Item ID: D3166-1 Accept ***N900040100*** Setup Start ***NS1***
 Revision ID: Stop ***NS2***
 Item Name: Basket Hoop
 Start Date: 4/20/15 Start Qty: 6.00 ***6*** Cust Item ID:
 Required Date: 4/20/15 Req'd Qty: 6.00 ***6*** Customer:
 Reference:

DESIGN #	DRAWN BY CP	DART AEROSPACE LTD HAWKESBURY, ONTARIO, CANADA	
CHECKED #	APPROVED #	DRAWING NO. D3166	REV. A SHEET 1 OF 1
DATE 02.07.10		TITLE BASKET HOOP	SCALE NTS
A	02.07.10	NEW ISSUE	
A1	04.04.08	38+/-1 WAS 36.0

DRAWING NO. D3166	TITLE BASKET HOOP	REV A1	DART AEROSPACE LTD ENGINEERING ORDER		D.E.O. NO. D3166-A-2	SHEET NO. 1 OF 1	SCALE NTS
DRAWN AJS	CHECKED [Signature]	MFG. APPR. [Signature]	APPROVED [Signature]		DE APPR. [Signature]		
DATE 08.12.11	DATE 08.12.15	DATE 08/12/15	DATE 08/12/16		DATE 08.12.16

D3166-1 BASKET HOOP

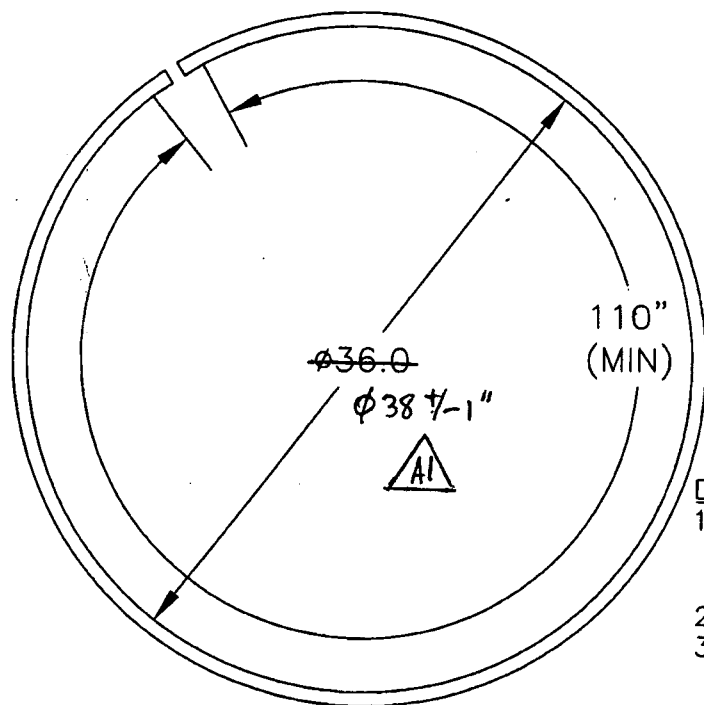
1) MODIFY MATERIAL NOTE FOR D3166-1 AS SHOWN:

WAS:

- 1) MATERIAL: AISI 304/316 SS SQUARE TUBING,
0.75" x 0.75" x 0.063 WALL, 60.00" LONG
(REF DART SPEC. M304TS0.750W.063)

2) MODIFY MATERIAL NOTE FOR D3166-3 AS SHOWN:

WAS:

- 1) MATERIAL: AISI 304/316 SS SQUARE TUBING,
0.75" x 0.75" x 0.063 WALL, 120.00" LONG
(REF DART SPEC. M304TS0.750W.063)

IS:

- 1) MATERIAL: AISI 304/316 SS, 3/4 X 3/4 X 0.065 WALL SQUARE TUBING,
60.00" LONG
REF. DART SPEC M304TS0.750W.065

IS:

- 1) MATERIAL: AISI 304/316 SS, 3/4 X 3/4 X 0.065 WALL SQUARE TUBING,
120.00" LONG
REF. DART SPEC M304TS0.750W.065
